## Front Suspension – Knocks – New “V” Mount Introduced

MODEL 1995 MY  
Sedan RangeVIN  
720001 - 722757**ISSUE:**

ILLUSTRATION 1

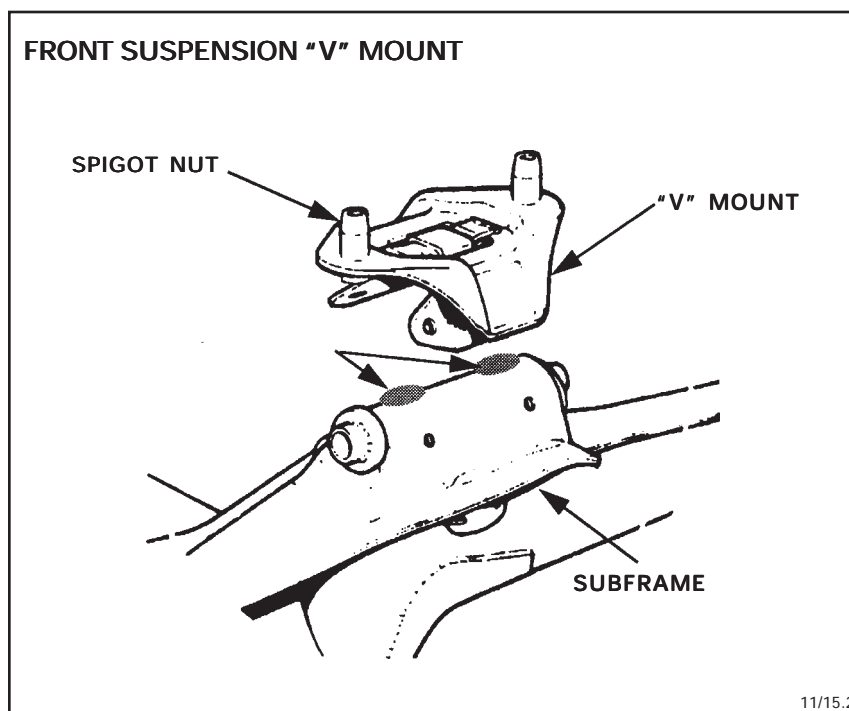
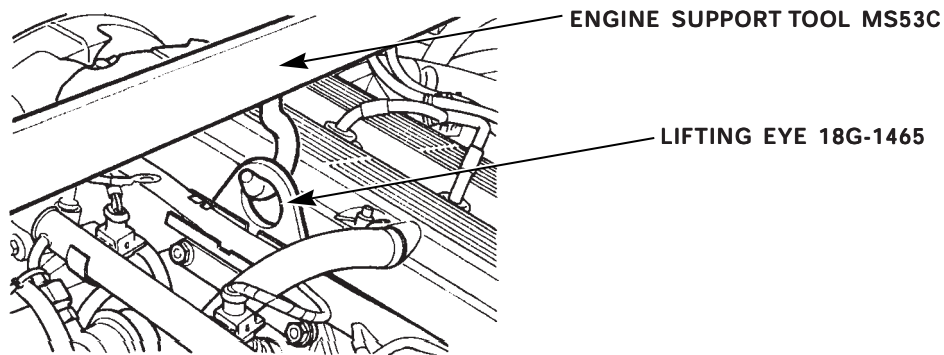
Knocks or rattles from the front suspension of 1995 MY Sedan Range vehicles within the above VIN range may be caused by the front suspension “V” mount spigot nuts contacting the front subframe (crossbeam). A new “V” mount with shorter spigot nuts was introduced in production at VIN 722758.

If a customer complains of a hard knock from the front suspension of a 1995 MY Sedan Range vehicle within the above VIN range when driving over a rough road surface, check for evidence of contact between the front suspension “V” mount spigot nuts and the front suspension subframe (Illustration 1). If contact is found, replace the existing front suspension “V” mounts with new “V” mounts (part number MNA 2360AD) as follows:
